**Airways New Zealand Petition**  
**to**  
**The Director of Civil Aviation**  
**to**  
**1. amend the Wellington CTR/C and CTA/C**  
**and**  
**2. delete and add VRPs**  
**and**  
**3. amend transit lane NZT656 Porirua**  
**and**  
**4. designate a new transit lane near Turakirae Head**

**14 December 2017**

Prepared by: John Wagtendonk  
ATS Policy and Standards  
Airways New Zealand  
03 3581620  
[j.wagtendonk@airways.co.nz](mailto:j.wagtendonk@airways.co.nz)

Diagram 1 Requested WN CTR. White lines are the existing CTR and CTA boundaries to be deleted. Existing and new waypoints for IFR procedures are included on the diagram.

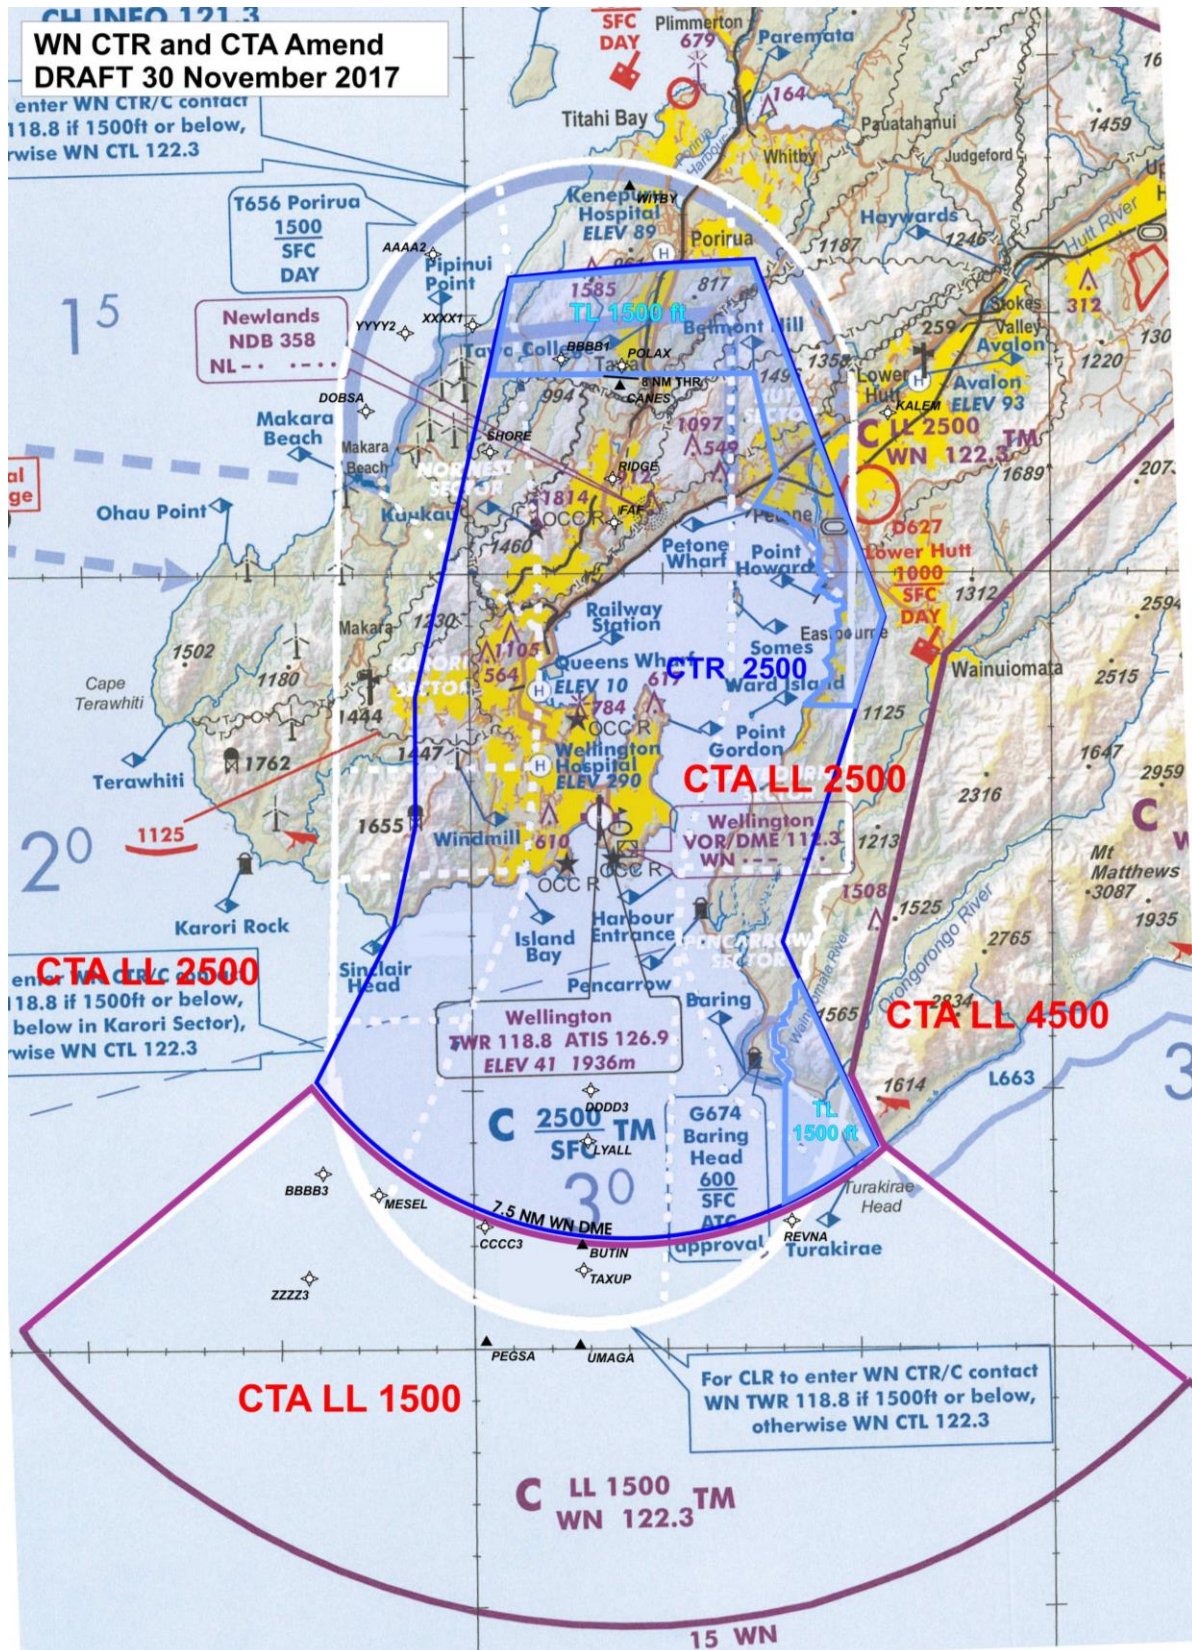
The requested amended WN CTR/C (NZA659) is depicted on Diagram 1 below.

The upper limit remains at 2500 ft AMSL.

New performance based navigation (PBN) IFR approaches and departures have been designed for Wellington. Some of those procedures require small additions to the WN CTR and amendments to the WN CTA to ensure correct containment within controlled airspace.

Airways desires to reduce the size of the CTR/C as much as practical in order to release unneeded controlled airspace to Class G. This is in-line with CA Rule 71.

*Diagram 2 Requested CTR/C northern boundary which utilises the intersection of Main Road, Raiha Street and Kenepuru Drive.*

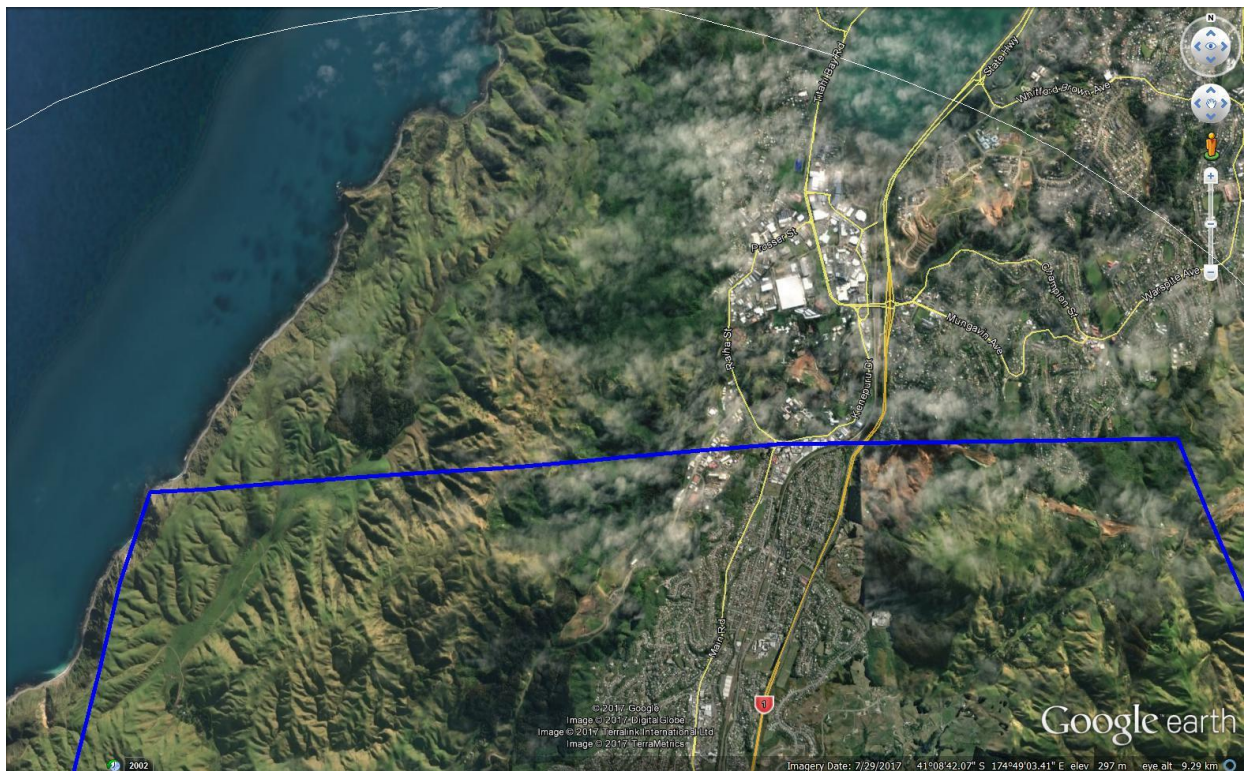
- Visual features are used to define the CTR boundary where possible as shown in the Google images below depicting some of the boundaries of the requested CTR. (Blue line is requested new CTR boundary and thin white line is existing CTR boundary.)

Diagram 6 Requested new CTR/C with planned new PBN turning SIDs.

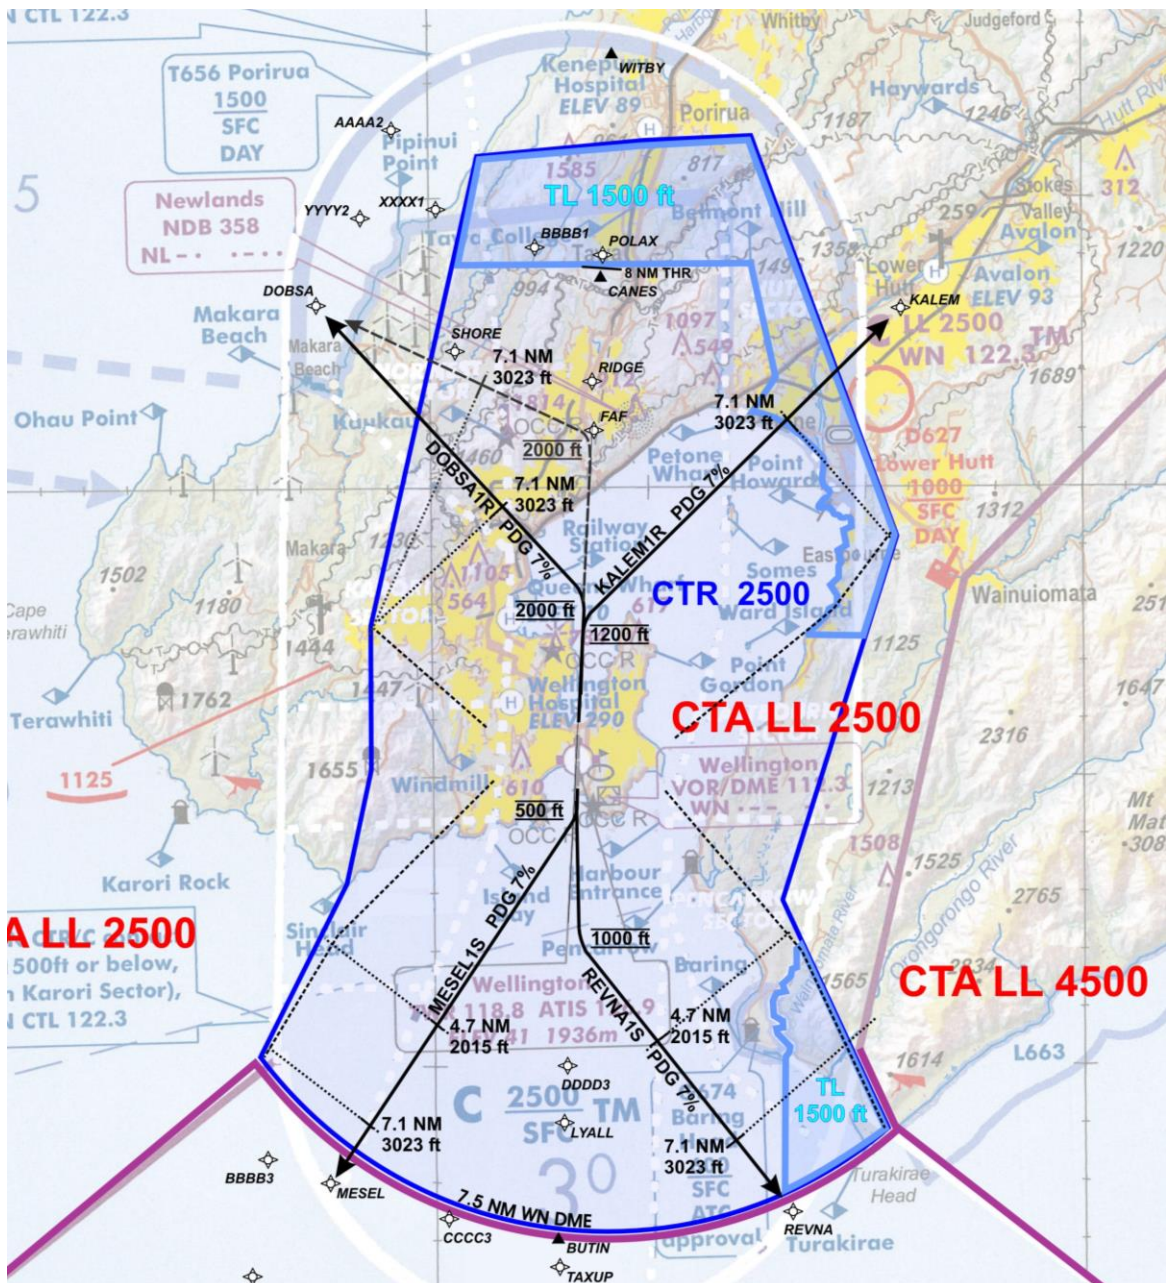
For the new PBN turning departures, an airspace containment profile of 420 ft per NM has been applied to contain their PDG 7%. This results in a narrower CTR than for a CTR designed for PDG 5% departures. Diagram 6 below depicts the requested WN CTR with the planned new PBN turning SIDs.

*Diagram 7 Requested amended northern transit lane (T656mod).*

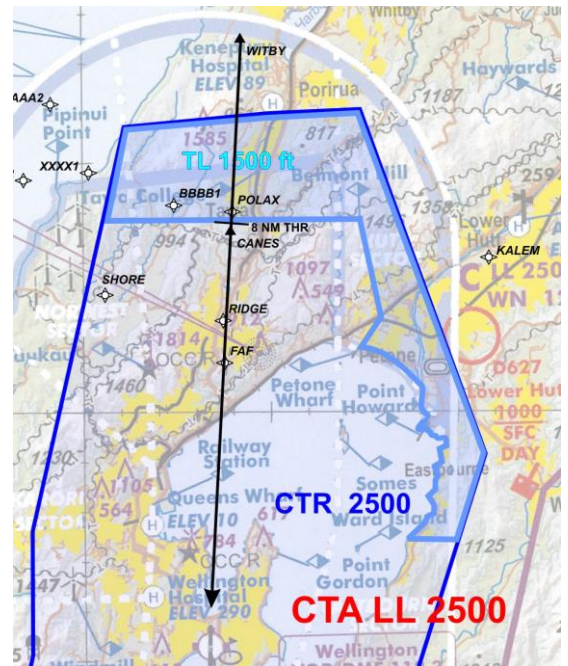
**NOTE:** The requested transit lane depicted in Diagram 7 and 8 is a later version than consulted with – the inner boundary between Belmont Hill VRP and Petone Wharf being changed.

The inner boundary of the northern transit lane under the final approach track is 8 NM from RWY 16 THR and therefore is not infringing containment of the approach – including 1 NM buffer allowance for visual fix error.

Feedback from local helicopter pilots was a desire for the inner boundary to be further south to include the power lines depicted on VNC – about 0.8 NM further south. This possibility was explored but the result was that the transit lane would infringe containment slightly of the approaches and departures applying the 300 ft per NM airspace containment profile and a 1 NM buffer being included due to the probability that the power lines are not sufficient to be a prominent geographical feature.

*Diagram 8 Google Earth image of requested amended northern transit lane inner boundary near Petone*

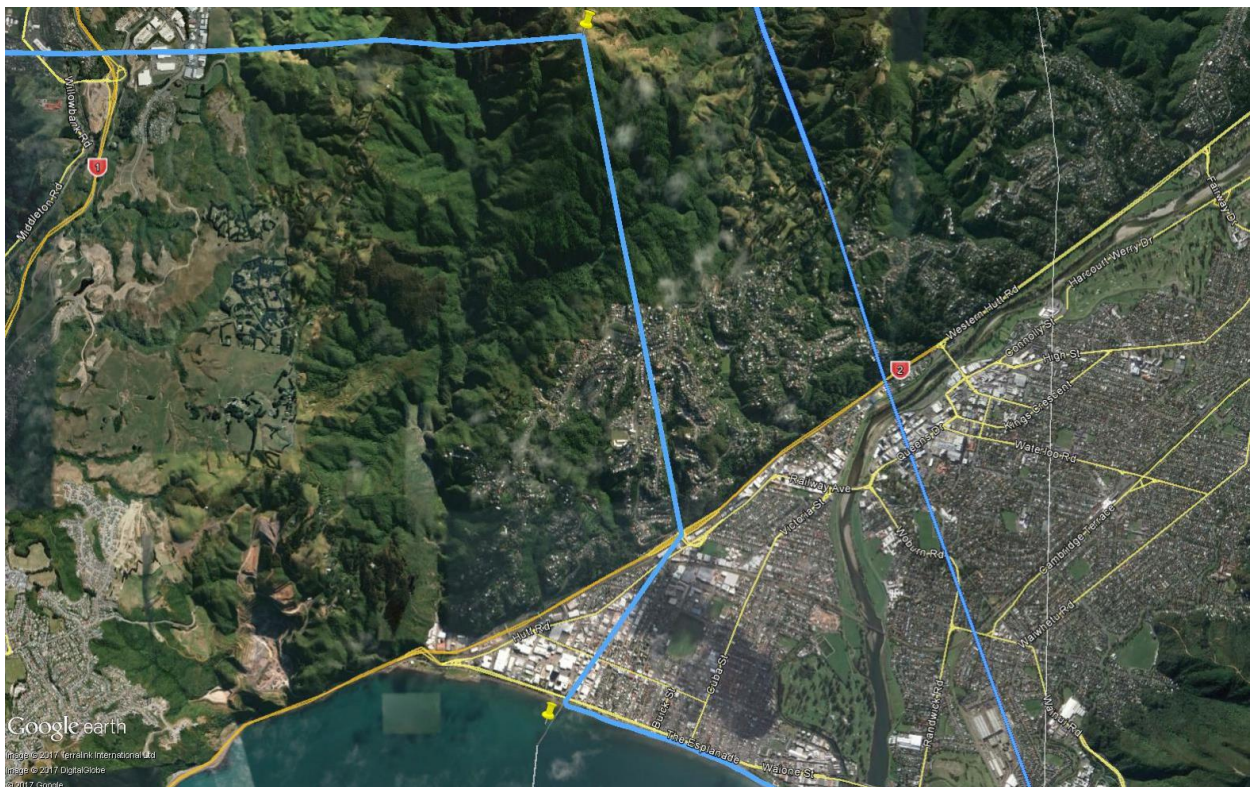
As shown on the Google Earth image Diagram 8 below, the transit lane inner boundary goes from Belmont Hill VRP to the roundabout on Western Hutt Road to the point where the Petone Wharf meets the Petone foreshore. It was not possible to utilise the Petone Wharf VRP as a corner for the transit lane boundary as that would have resulted in the transit lane very slightly infringing the Instrument Sector.

Diagram 9 Requested new transit lane on the coast west of Turakirae Head.

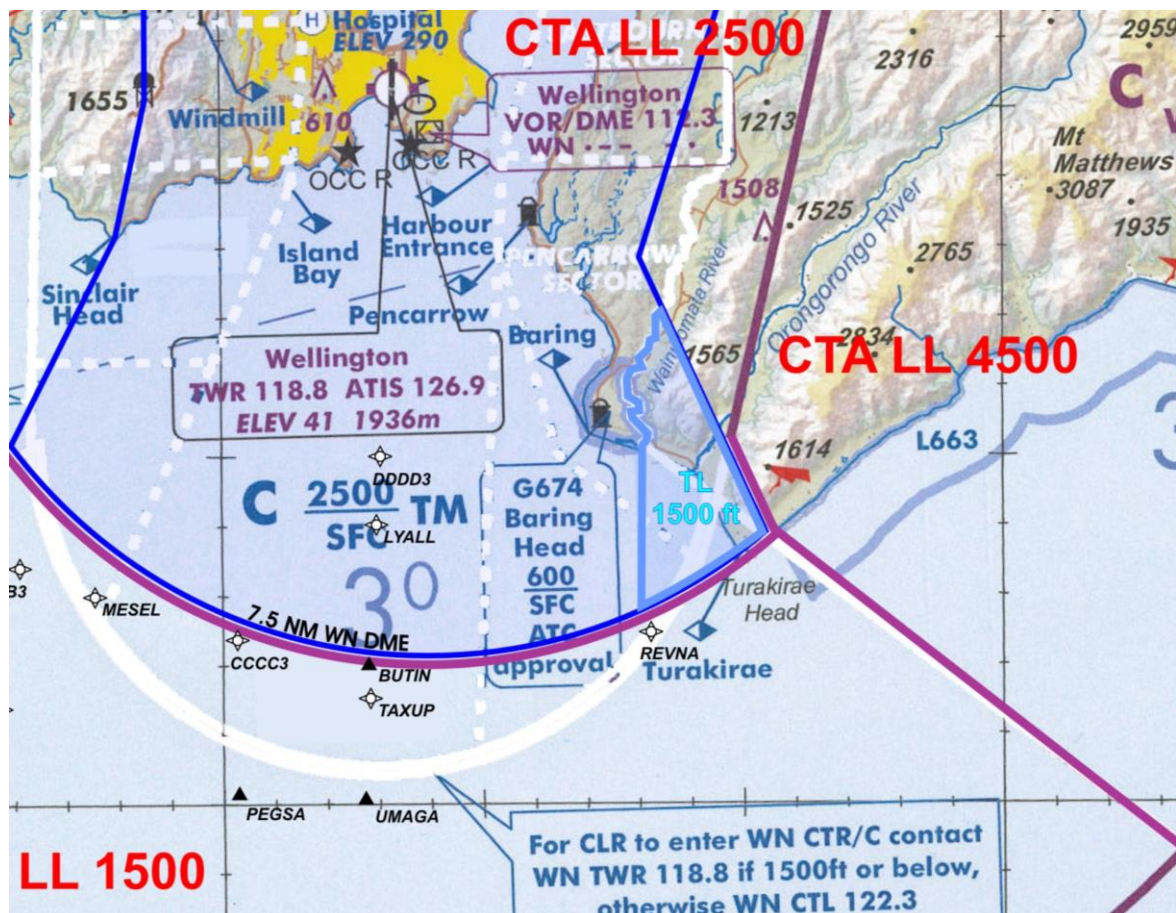
RTF comms between WN Tower and aircraft along the East Coast approaching Turakirae Head ('around the corner') at or below 1500 ft is often not possible – the aircraft need to be west of Turakirae Head before good comms is reliably established. It would generally not be possible for an aircraft to turn the corner at Turakirae without first obtaining a clearance to enter the CTR – that is likely not possible due to the RTF comms issue. A transit lane would address this lack of comms situation and avoid aircraft having to track out to sea whilst requesting and receiving a clearance to enter the CTR.

Feedback from a local GA operator copied below indicates a need for a small transit lane to be established along the coast west of Turakirae Head.

A transit lane would be perfect for aircraft entering or exiting the Orongorongo valley and for aircraft to hold, to stay out of the lee of Turakirae Head in a westerly or north westerly wind. My concern here is that if there is a wind shift or increase, particularly to a strong westerly or north westerly and a pilot chooses to return, they would typically hold to the south or slightly southwest of Turakirae head to remain out of the lee. In the proposed airspace change, the new airspace would not allow for this. This scenario does happen on occasion as the weather is not always predictable. I have a safety concern here that a pilot will either bust airspace to clear the lee of Turakirae head or risk holding in severe turbulence whilst potentially getting caught in downdraught.

In response to the above issues, Airways is proposing a new transit lane up to 1500 ft AMSL is established between Turakirae Head and Baring Head as shown on Diagram 9 below. This additional transit lane has not been consulted with local operators – it is designed in response to feedback received from earlier consultation.

Diagram 10 Google Earth image showing:  
 requested transit lane - thick blue line    existing G674 – thin turquoise line  
 requested CTR boundary – thin blue line    existing CTR boundary – white line

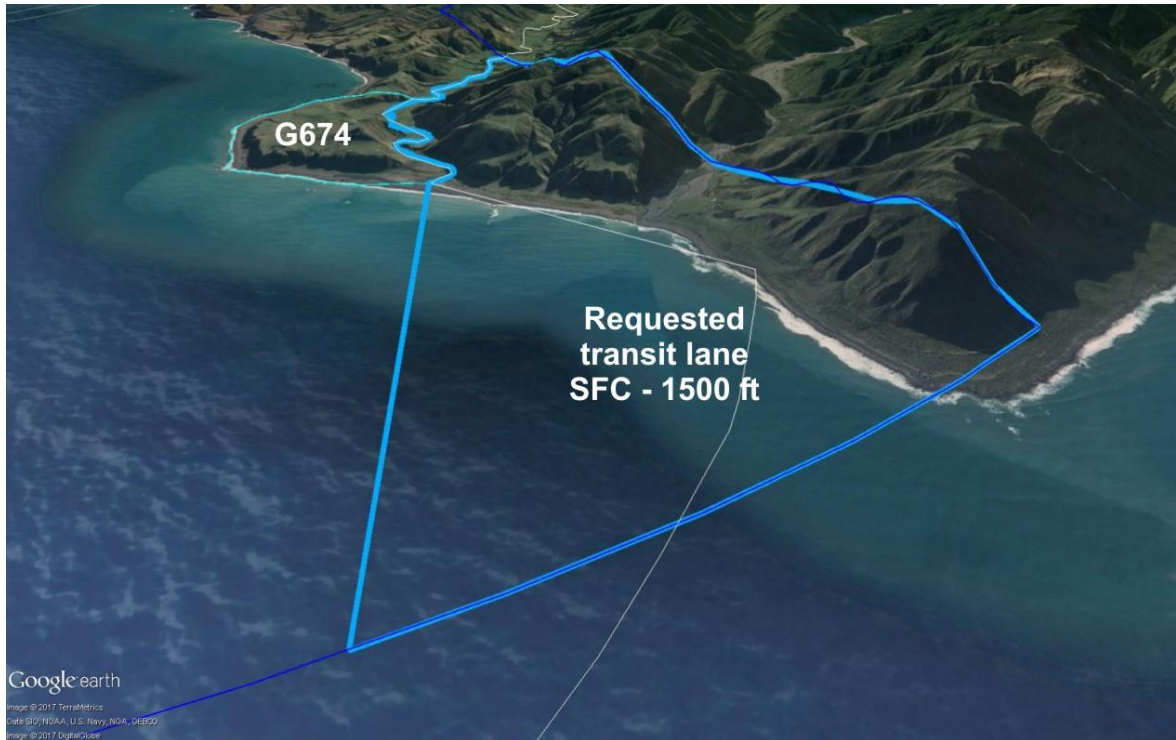
The western boundary of the transit lane would follow the Wainuiomata River, the same as the existing CTR boundary, to the coast and from there seaward of the coast. At its widest at the southern boundary the transit lane is 1.5 NM seaward of the coast.

NZG674 Baring Head (SFC to 600 ft) adjoins the transit lane.

Diagram 11 Planned new REVNA departure is not infringed by the transit lane.

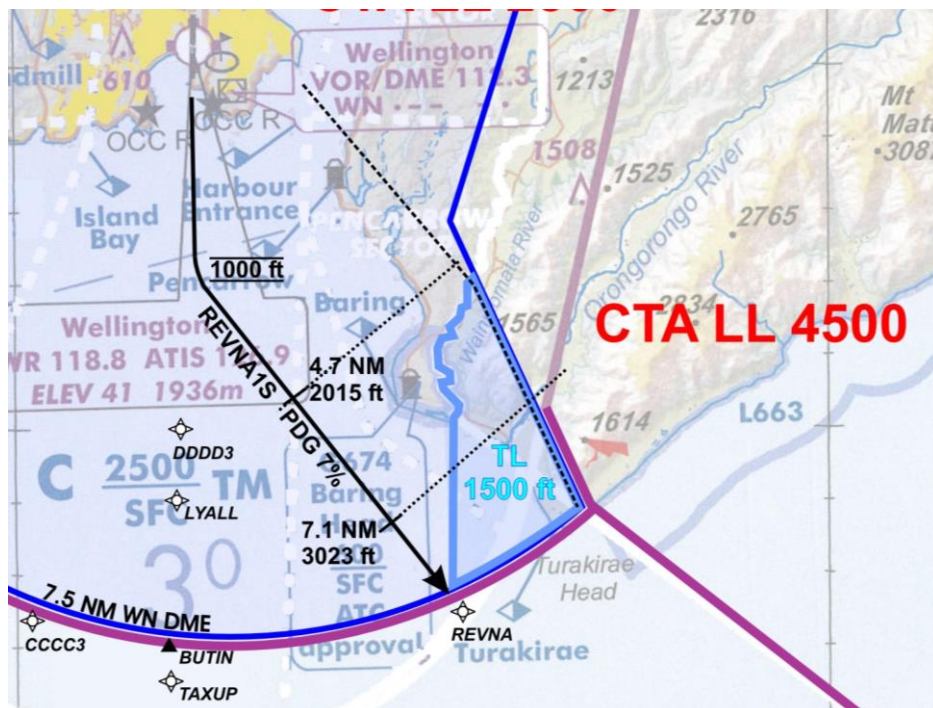
As shown on Diagram 11 below, the transit lane would not infringe airspace containment of the planned new REVNA departure. Applying 420 ft per NM to contain the departure's 7% PDG, the profile passes 2015 ft at 4.7 NM from THR, 0.7 NM before reaching the transit lane boundary. The transit lane boundary follows the river, a prominent geographical feature, therefore a 1 NM buffer does not need to be added.

Diagram 12 Possible CTR western boundary.

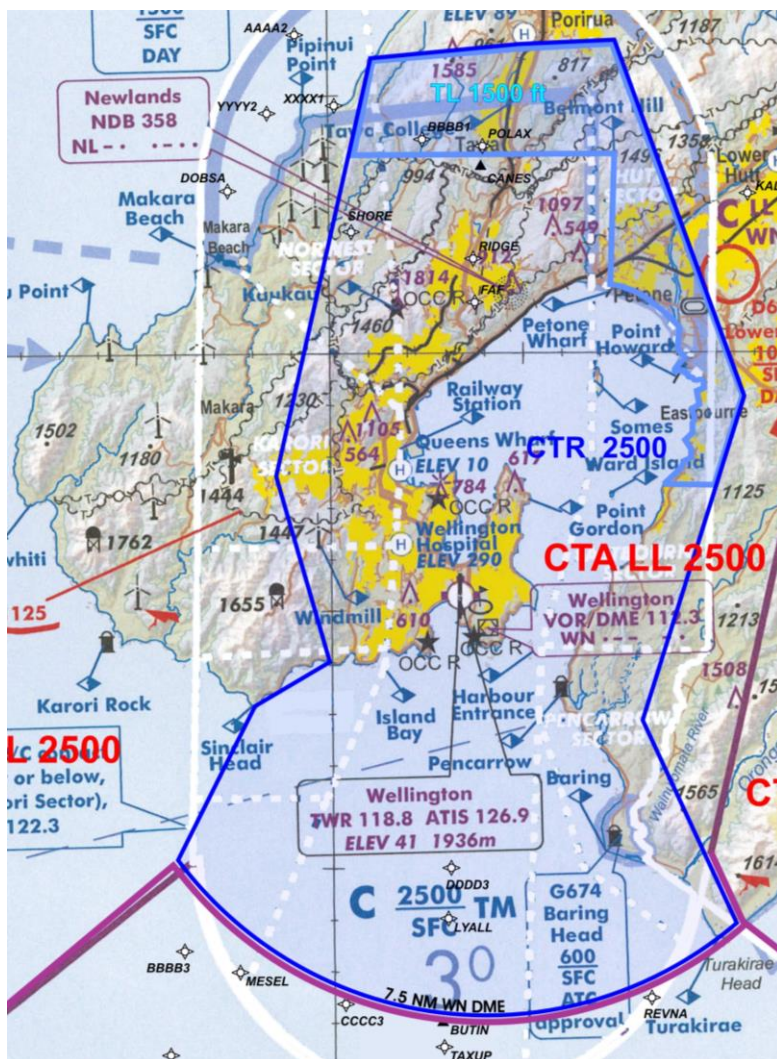
Feedback from the glider operator also strongly urged Airways to consider a small change to our proposed CTR to the west near Sinclair Head – Owhiro Bay to facilitate glider operations.

The area concerned is shown on the diagram below. The green shaded area is outside the instrument sectors for the WN approaches and departures and is clear of the WN circuit area. The CTR boundary that the operator is requesting is marked on their diagram below by the solid black line from the radar symbol to the western point of Owhiro Bay to Sinclair Head VRP so that that triangular area would be outside the CTR.

Airways has considered this request. That triangular area is not needed for the containment of instrument procedures or the aerodrome vicinity/circuits so the CTR boundary could follow the requested black line. **However, we have not amended our requested CTR to incorporate that change because;**

1. we are unsure what impact the hang gliding and paragliding operations (perhaps intensive at times) could have on VFR aircraft arriving and departing through or near that area. Our experience shows that VFR operations, including commercial operations by Caravan aircraft, do regularly occur on and inland of the coast in that area:
2. we believe that a VFR arriving aircraft could get trapped without a clearance in that triangular indentation in the CTR – it can enter that triangular area before obtaining an ATC clearance to enter the CTR and if a clearance was not immediately issued, where would the aircraft track? There may be insufficient room for it to turn to remain outside the CTR which would result in an airspace infringement:
3. we believe that an indentation in the CTR boundary like that is probably contrary to the airspace design objective of simplicity of design.

A possible CTR boundary that may address some of our concerns raised above is depicted in Diagram 12 below. **Airways is not petitioning for this** but would not have any objections if this CTR boundary was designated by CAA. Note though that the exact location of the Owhiro Bay corner is critical as it is very close to the edge of the instrument sector for the west-turning departure. If this goes ahead, Airways would need to be involved with the final design.
